(R) BOLT, MACHINE - HEXAGON HEAD, FULL SHANK, CORROSION RESISTANT STEEL (UNS S17400), 140 KSI MIN UTS, .5000-20 UNJF-3A

AS9788
SHEET 1 OF 2

REV. A

FIGURE 1 - BOLT

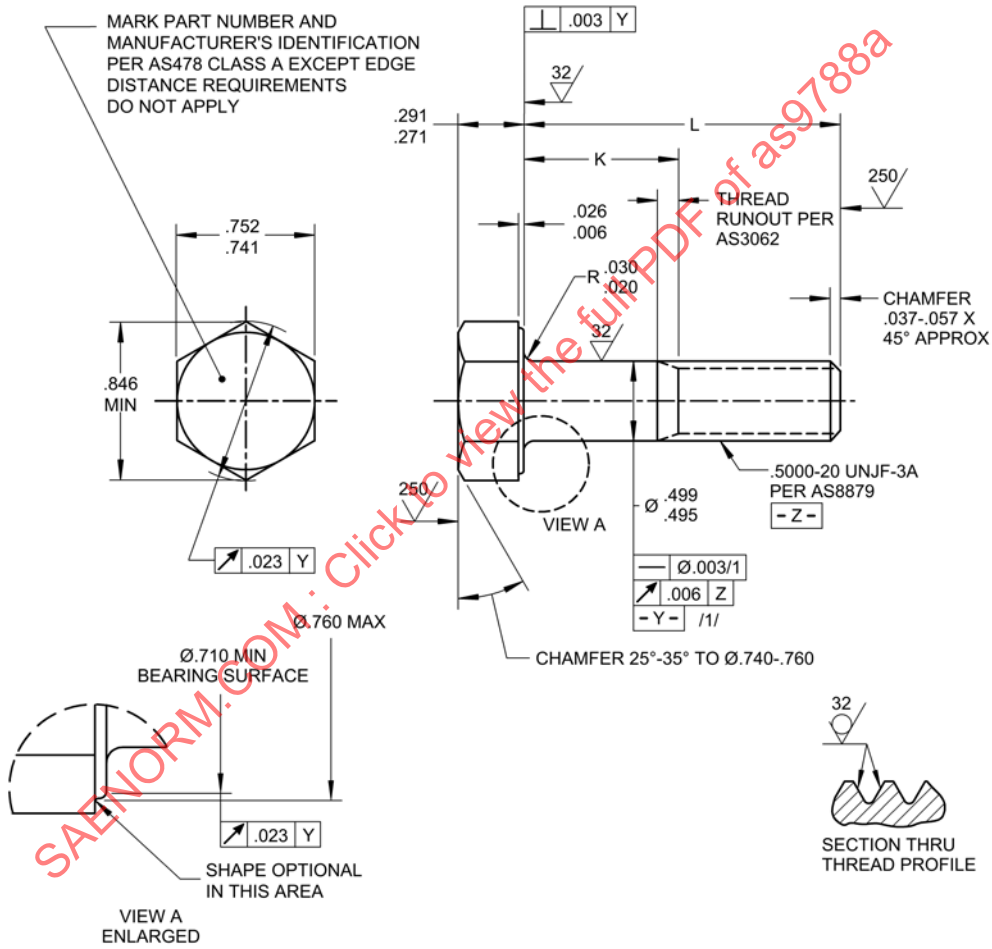
UPDATE THREAD SPECIFICATION TO AS8879, UPDATE TO ANSI Y14.5M-1982, REVISE FPI REQUIREMENTS TO ASTM E1417/1417M, ADD EDGE DISTANCE EXCEPTION FOR HEAD MARKING, ADD NEW NOTE TO REPLACE DATUM Y WITH DATUM Z FOR SHORT LENGTHS, ADD AS3062 FOR THREAD RUNOUT, CONVERT GD&T NOTES TO FEATURE CONTROL FRAMES, DATUMS, AND SYMBOLS, ADD SURFACE TEXTURE REQUIREMENTS FOR TOP AND END, ADD SURFACE TEXTURE SYMBOLS PER ASME Y14.36M, FIGURE 1 REDRAWN AND GENERAL EDITORIAL UPDATE.
